Notice of Decision

Site Plan Review for Modification of Existing Development

SP-22-24 September 12, 2024

Proposal: Redevelopment of portions of Deerfield Park with a new play area, basketball

LANDSCAPE SITE PLAN

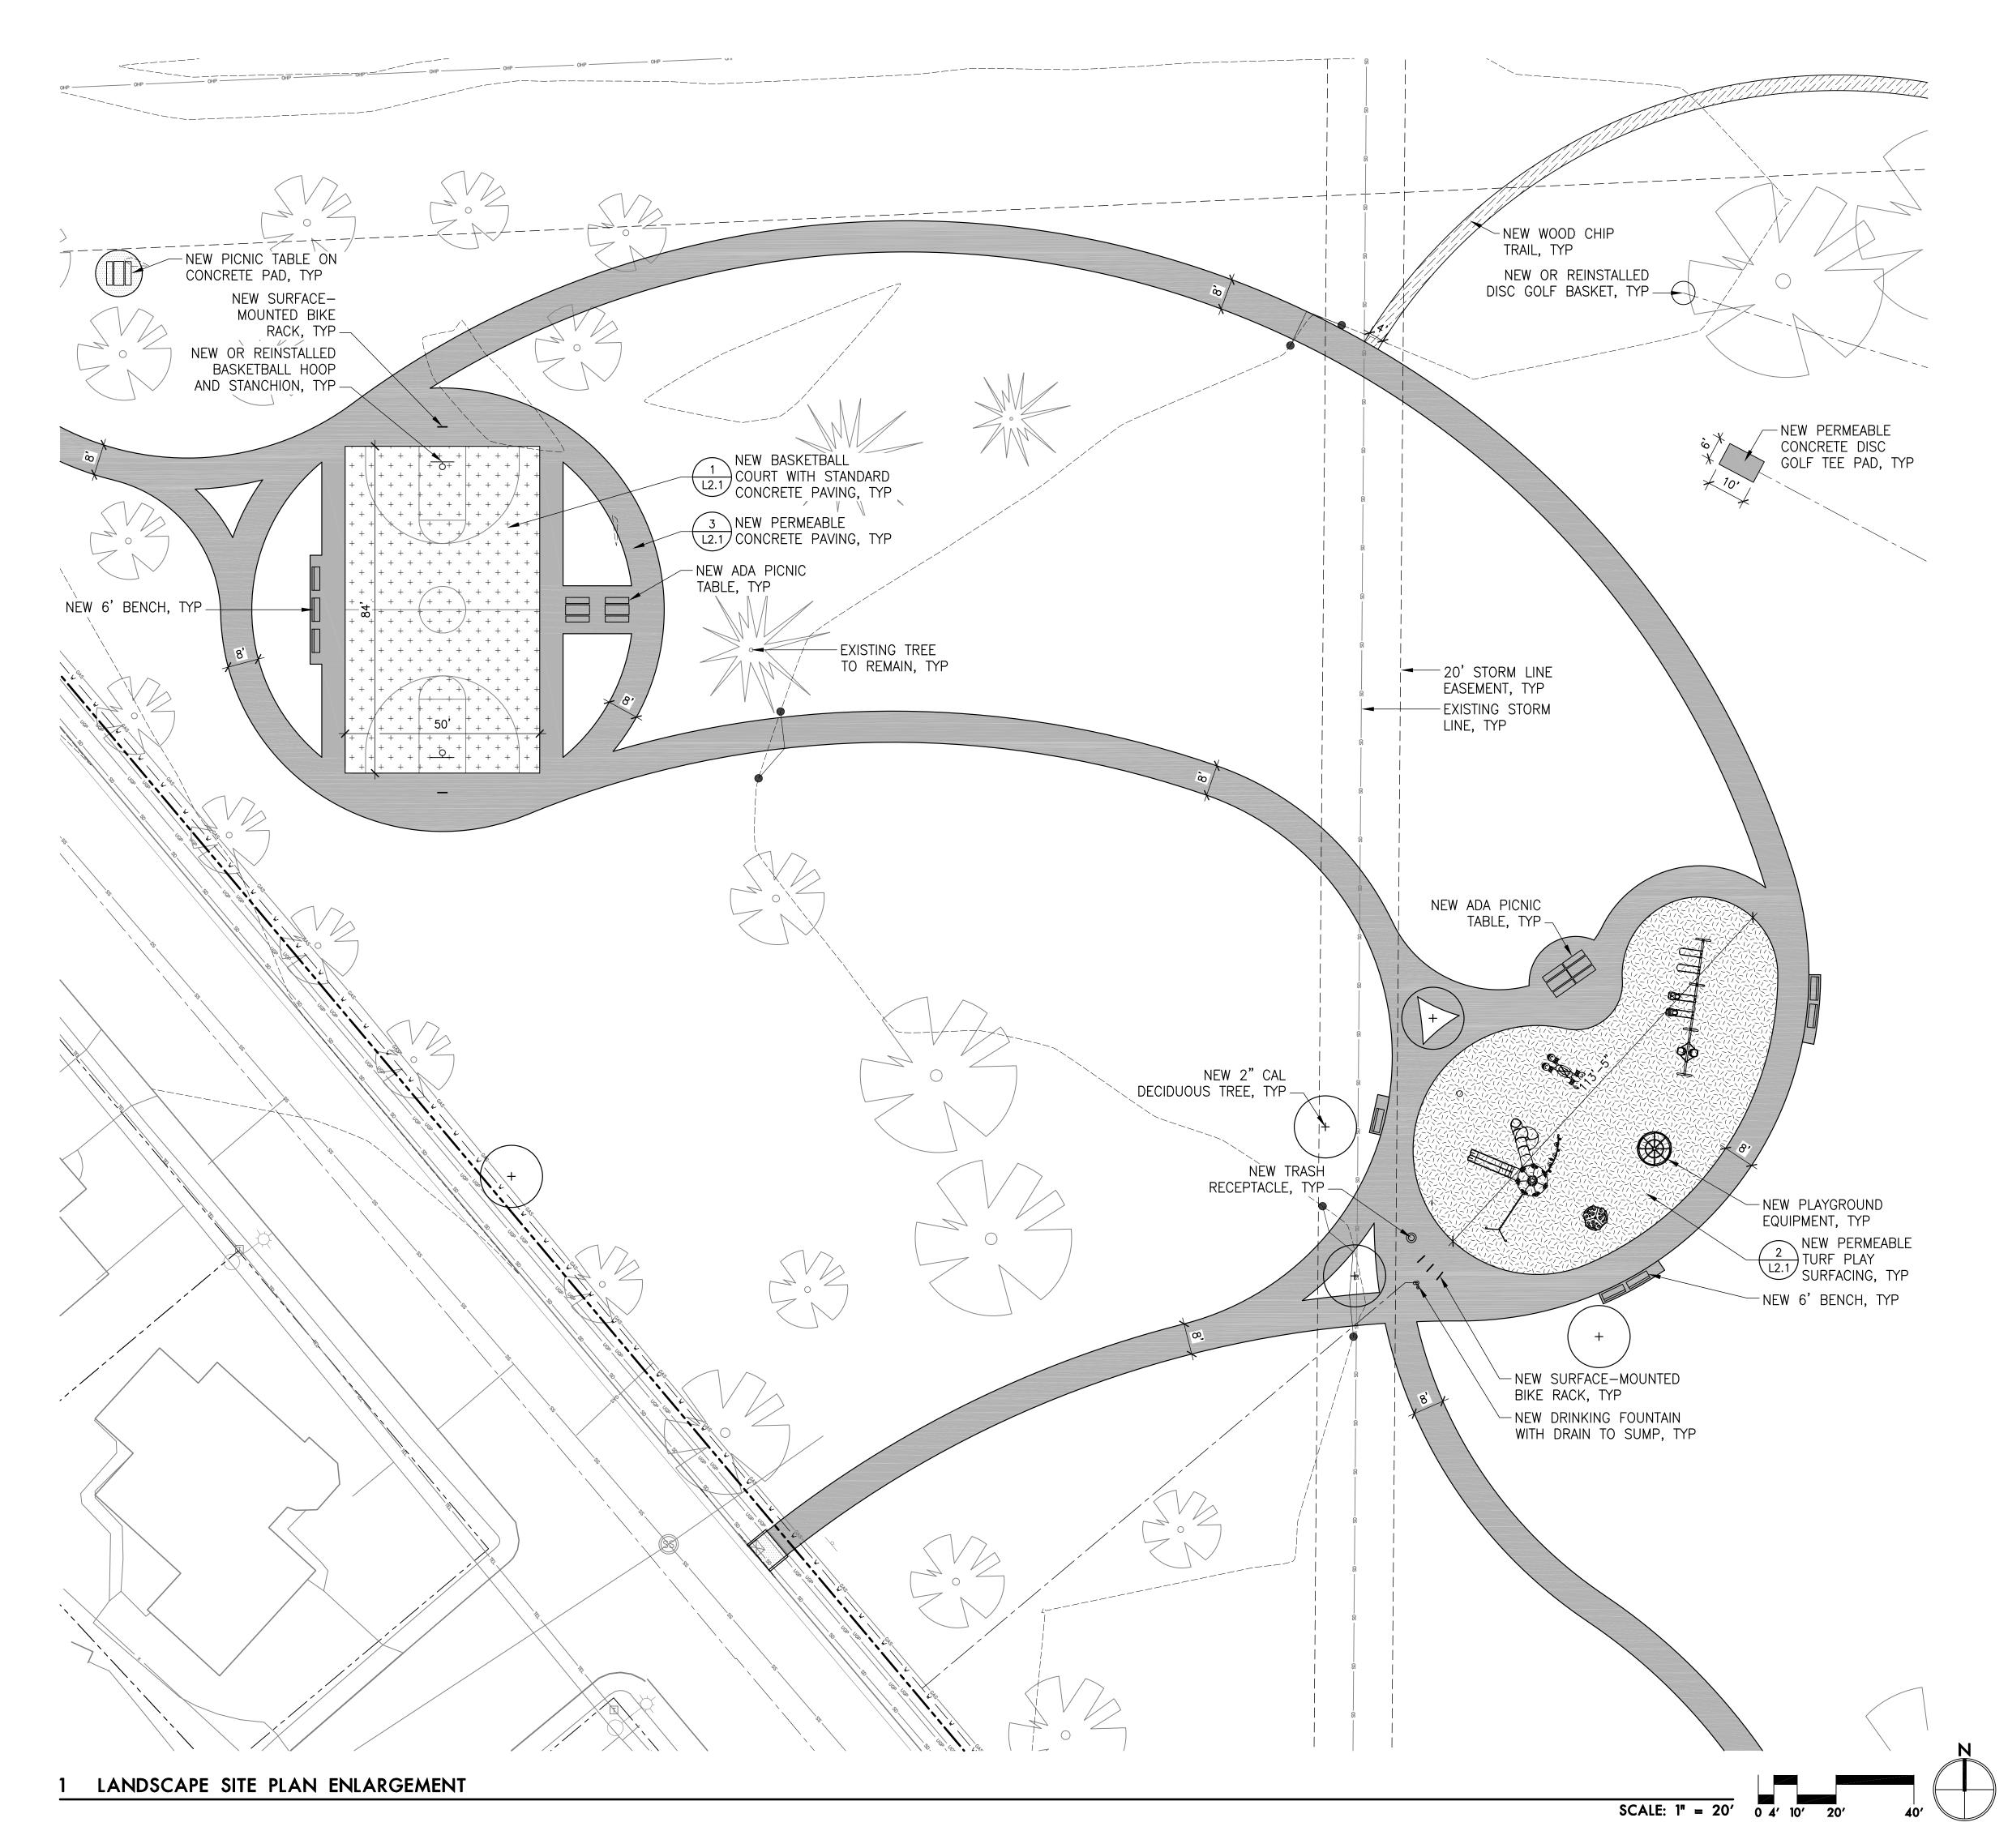
- Condition 1 Site Improvements. Prior to the commencement of the use, all proposed and site improvements identified to the site plan (e.g., driveways, landscaping, lighting, etc.) shall be constructed and completed in accordance with approved plans. Landscaping may be financially secured through a completion guarantee, per ADC 9.190.

- Condition 2 Landscaping and Irrigation System. Prior to the commencement of the use, the applicant shall provide a landscape plan, which shall include 40 trees between the path/sidewalk and Del Rio Avenue SE in conformance with ADC 9.140, and either an irrigation plan or a letter from a qualified landscape professional stating irrigation is not required per ADC 9.160.

- Condition 3 Utilities. Prior to the commencement of the use, the applicant must obtain a stormwater quality permit through the City's Public Works Department and construction of pervious concrete. The applicant shall enter into an Operation and Maintenance Agreement for the maintenance of pervious concrete.

- **Condition 4 Transportation.** Prior to the commencement of the use, the applicant shall obtain an encroachment permit for connection to the public sidewalk within the public right-of-way and construction of a new ADA ramp at the Del Rio Avenue and Del Rio Court intersection.
